File No: NTH24/00543/001

Your Ref: SSD-70748466 - PAE-73538712

RE: Review of Environmental Impact Statement (SSD-70748466) - Advice on EIS - Huntlee New Town - Stage 2 - Wine Country Drive Rothbury

Figure 8.7: Rural CHL treatment with an acceleration lane

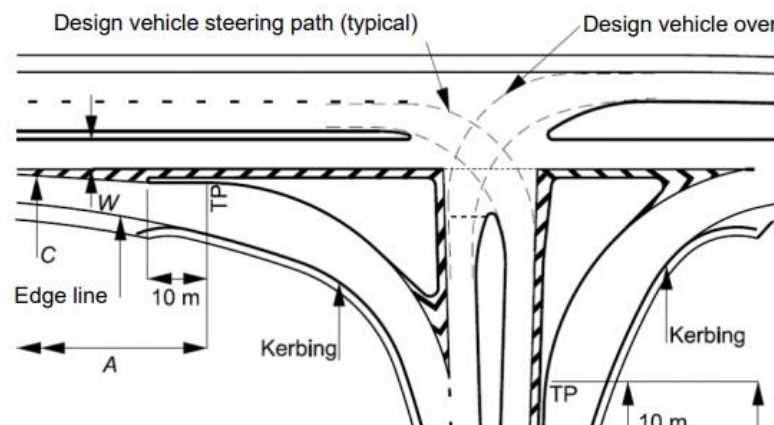
- Where the new slip lane joins the existing westbound highway entry ramp, the raised island nose should run parallel for 10m after the tangent to force a parallel merge in accordance with AGRD 4a figure 8.7. In this area, a space is also required for cyclist to cross with care. See image below titled 'Figure 8:7 Rural CHL treatment with an acceleration lane'.
